UNITED STATES
NUCLEAR REGULATORY COMMISSION
WASHINGTON, D. C. 20555

Docket Nos.: 50-329/330

APPLICANT: Consumers Power Company
FACILITY: Midland Plant, Units 1 and 2
SUBJECT: SUMMARY OF THE MAY 23, 1980 MEETING ON PRESERVICE FAILURE OF
THREE REACTOR VESSEL HOLD-DOWN STUDS

Slide 1

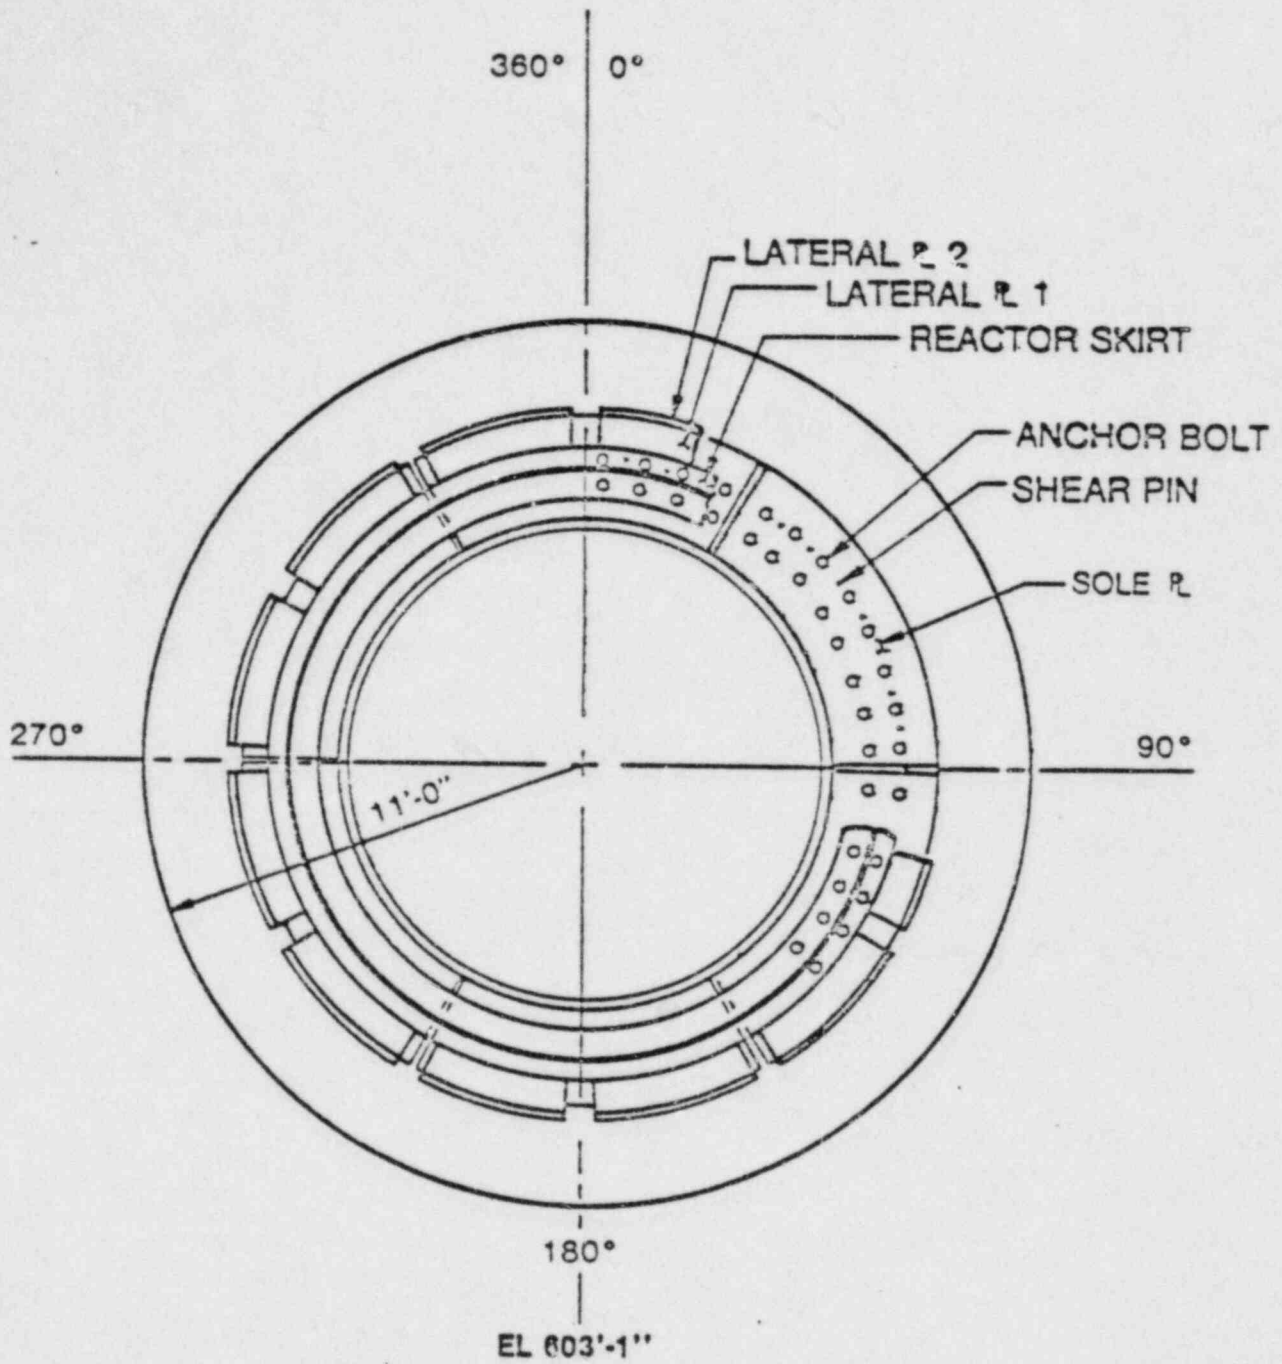
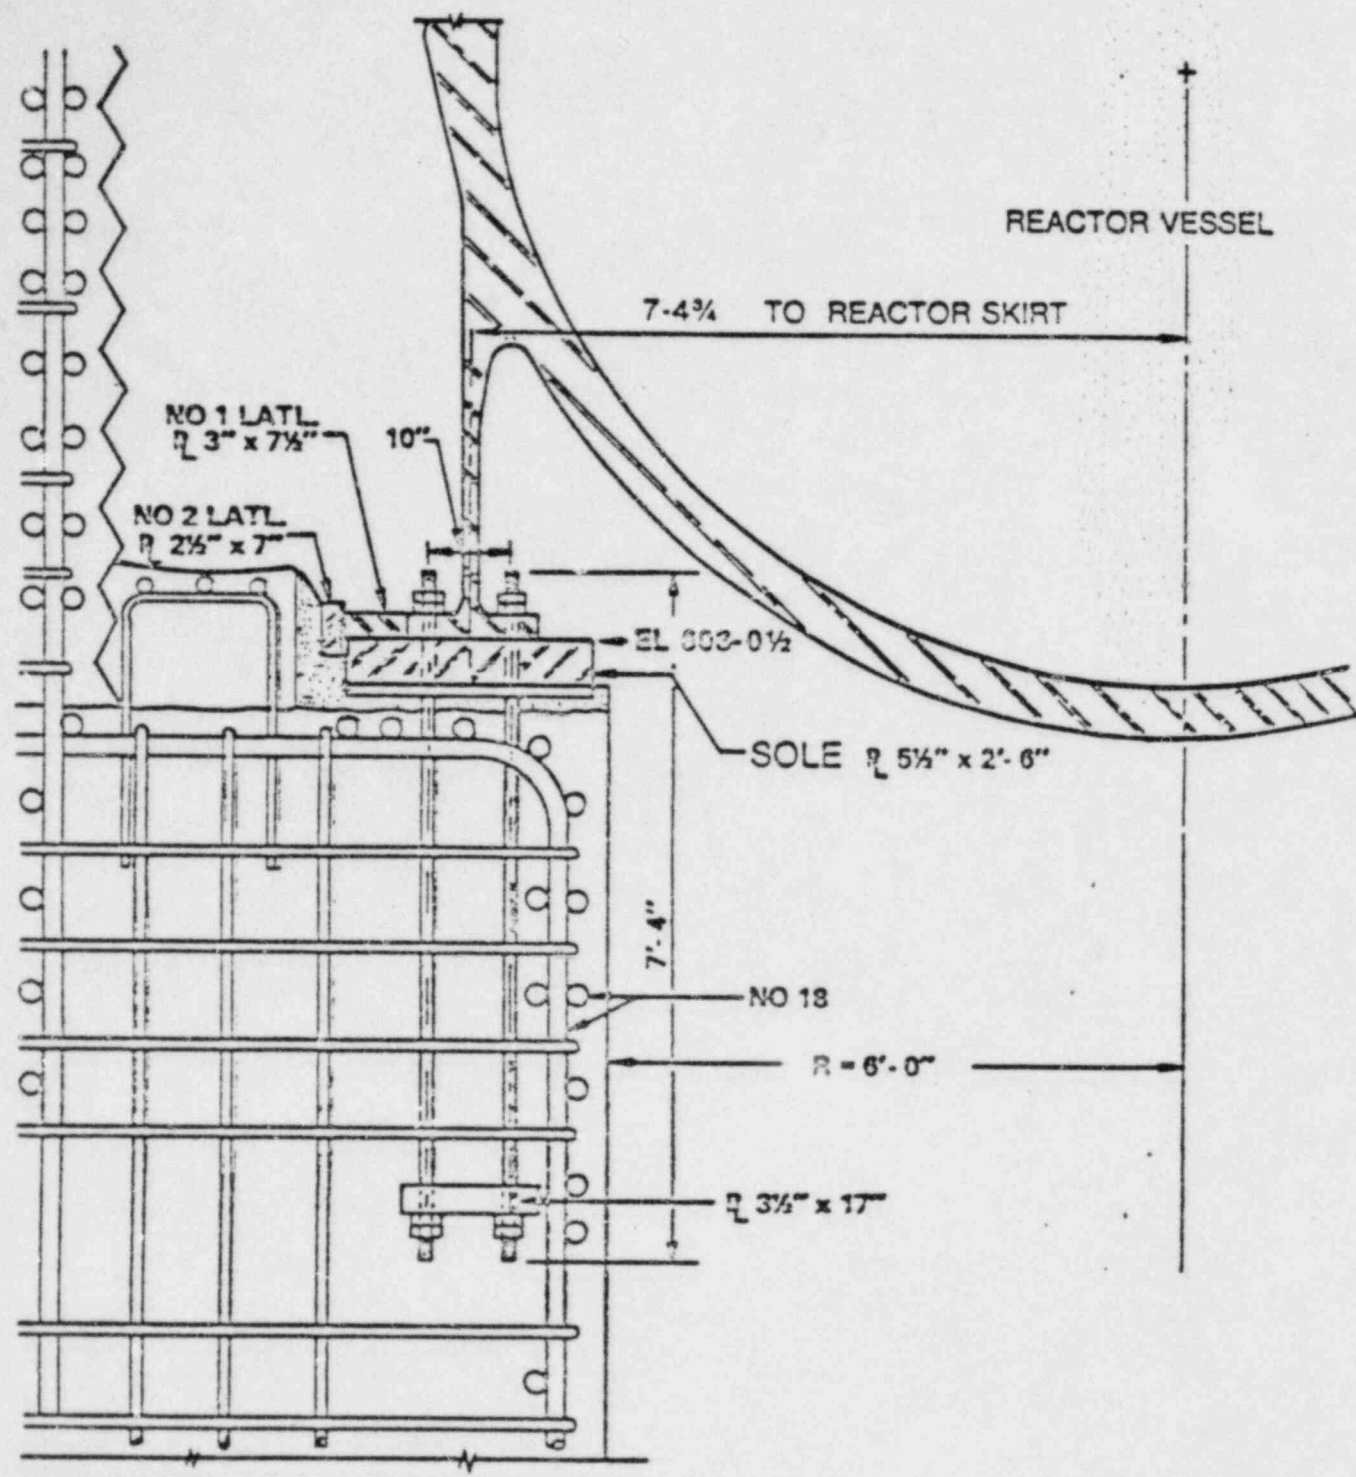
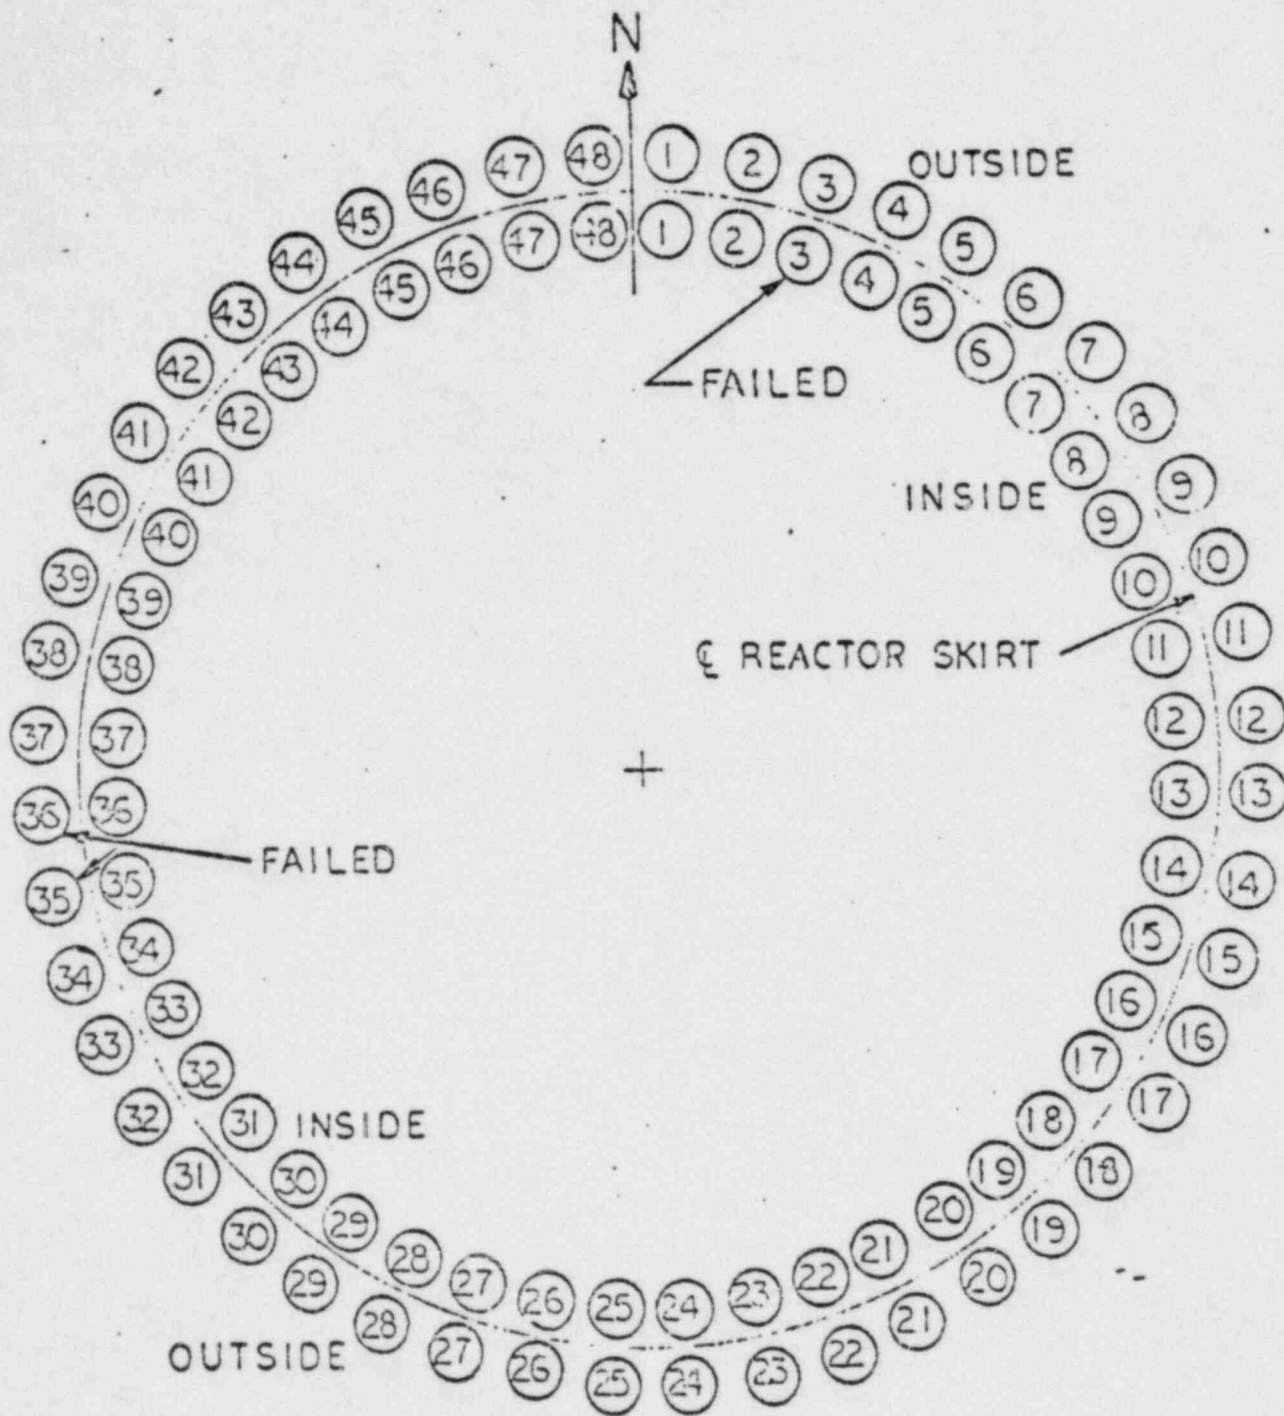
The holddown design for the Midland reactor vessels is shown on Slides 1, 2 and 3 of Enclosure 3. Further detail is shown on FSAR Figure 3.8-30. The design utilizes 96 anchor studs, each 7 feet 4 inches long and 2 1/2 inches in diameter, embedded vertically in the reinforced concrete reactor vessel pedestal and arranged in two concentric rows of 48 studs each. All studs were purchased by Bechtel to a modified version of ASTM-A354-66, Grade BD standards under Bechtel Specification 7220-C-223(Q), Rev. 3. The modification was a waiver of the maximum diameter allowed in the 1966 version for Grade BD bolts. The studs for Midland Unit 1 are nominally AISI 4140 and 4145, while the studs for Unit 2 are all nominally AISI 4340. Stud failure has occurred in Unit 1 only. The Unit 1 failed studs were purchased from Mississippi Valley Structural Steel of St. Louis, Missouri and fabricated by Southern Bolt and Fastener of Shreveport, Louisiana. The stud material originated from Bethlehem Steel and the studs were heat treated by J. W. Rex of Lansdale, Pennsylvania.

As shown on Slide 2, the vessel skirt design also includes shear pins, 2 inches in diameter and 6 1/16 inches in length, to transmit lateral loads to the 5 1/2 inch thick annular sole plate segments beneath the skirt. Shear lugs are welded beneath the sole plate. Lateral and torsional loads therefore, are resisted by friction, bearing, shear pins, and shear lugs, and transmitted to an inner ledge of the primary shield wall. The studs are intended to resist overturning moments and uplift forces acting on the reactor vessel, such as would result from a loss of coolant accident located so as to pressurize the reactor vessel subcompartment.

FIGURE 1.
 POSITION AND NUMBERING OF STUDS IN UNITS 1 AND 2
slide 4.

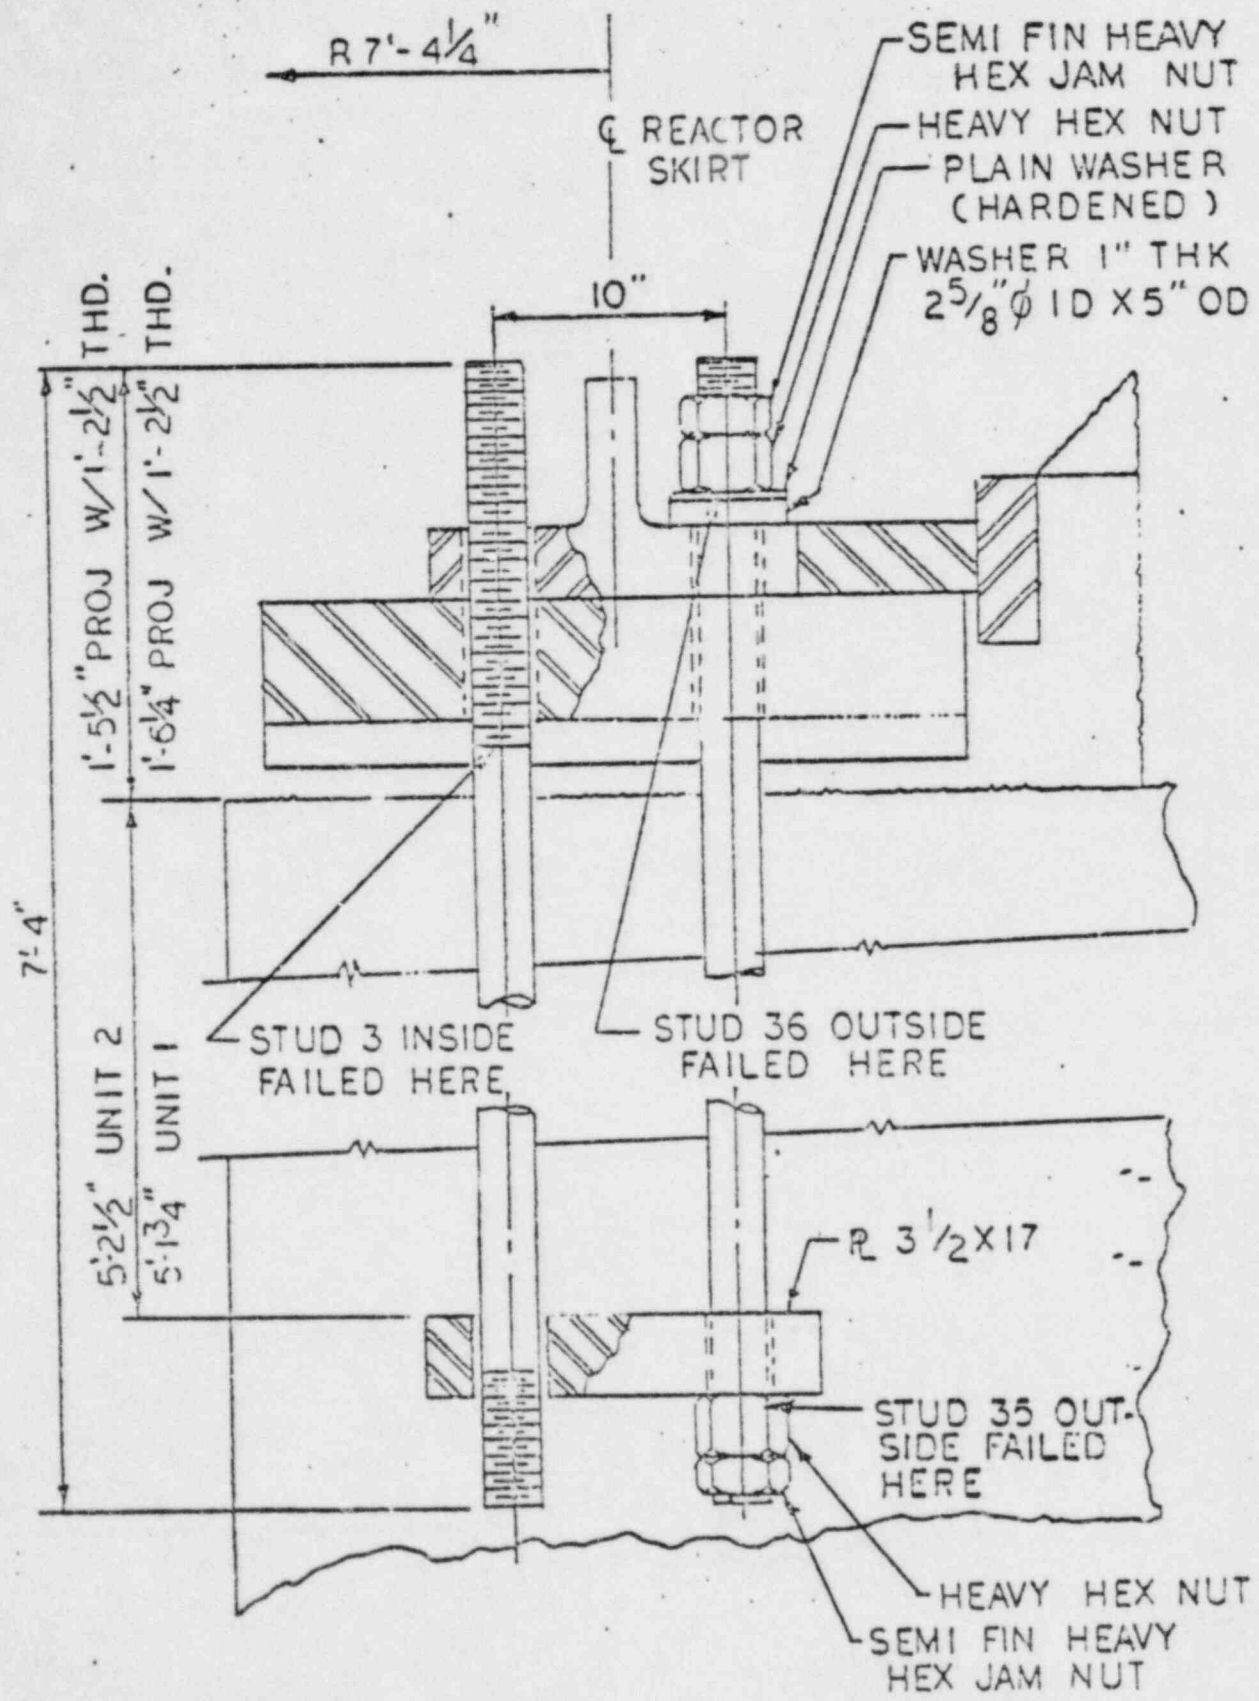
The identification of individual studs relative to position on the reactor vessel skirt are indicated in Slide 4 of Enclosure 3. The points of failure along the length of the three failed studs are shown by Slide 5.

On September 14, 1979 as B&W personnel were installing jam nuts on the anchor bolts, it was discovered that the stud and nut of stud 3 (inside row) were missing. A search by Bechtel personnel recovered the stud fragment on September 18th. Several minute dimples on the surface of the reactor vessel were caused by the ejection of the stud at the time of the spontaneous failure. A second failed stud (number 36, outside) was discovered on December 19, 1979.

On February 5, 1980, an I&E Regional Inspector visiting the site to observe the first two broken studs noticed that stud 35 (outside row and adjacent to failed stud 36) was off its seat about an inch. The stud was removed during the week of March 31, 1980 and was observed to be broken about 1/2 inch below the top of the bottom heavy hex nut. (Note: to prevent the studs from bonding to the concrete, a bond breaker was used from the top of the bottom anchor plate to the upper threads - the breaker consisted of Pennzoil Lubricant No. 952 and Visqueen.)
